**Model
Administrative Change Notice**

1. Document Number:	ANL-EBS-MD-000004	2. Revision:	02/AD 01	3. ACN:	02
4. Title:	General Corrosion and Localized Corrosion of the Drip Shield				
5. No. of Pages Attached:	14

1. Document Number:	ANL-EBS-MD-000004	2. Revision:	02/AD 01	3. ACN:	02
4. Title:	General Corrosion and Localized Corrosion of the Drip Shield

Figure 6-19[a]. Drip Shield General Corrosion Model for Benign Environmental Conditions along with the ECDF for the Experimental Data Used for the Model Analysis

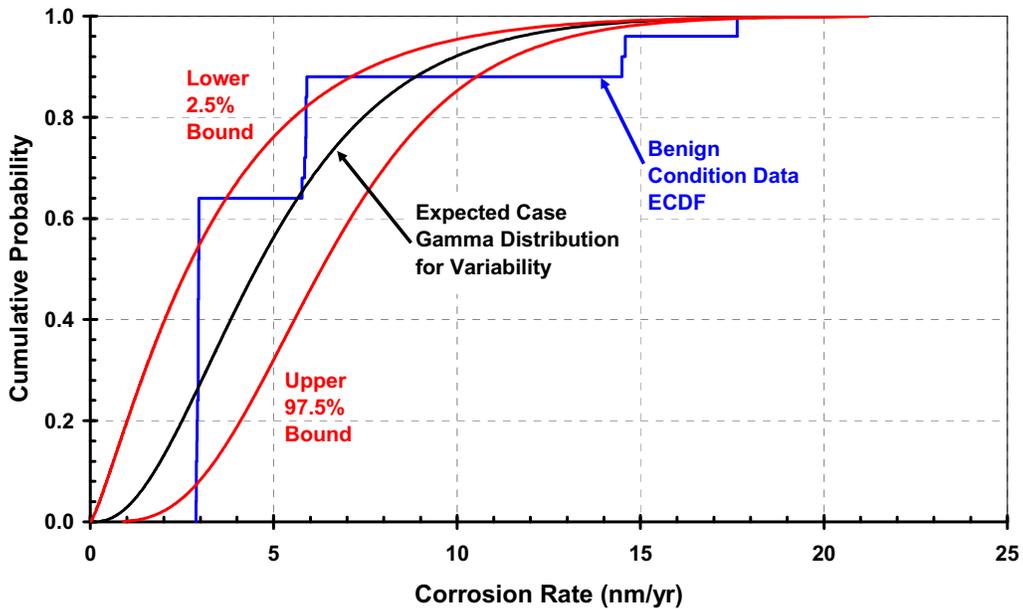
7. Affected Pages	8. Description of Change:
1-3	Clarified TSPA implementation independent of local seepage conditions. Defined that "coupon," "sample," and "specimen" all refer to the same type of tested material and are used interchangeably
6-4	Clarified modeling approach paragraph and discussion of implementation.
6-6	Rewrote the reasoning for exclusion of zero and negative corrosion rate data.
6-7, 6-8, & 6-14	Made zero and negative corrosion rate exclusion consistent with changes on p. 6-6.
6-13 & 6-19	Revised text and a table/figure caption to clarify the uncertainty discussion.

The small p-values presented in Table 6-6[a] indicate that, in the strictest sense, none of these models is entirely representative for these data. Figure 6-18[a] shows the ECDF for the benign condition corrosion data compared to the CDFs for gamma, Weibull, and lognormal distributions. While none of these three models fits this type of clustered data well, each provides a qualitatively similar level of approximation.
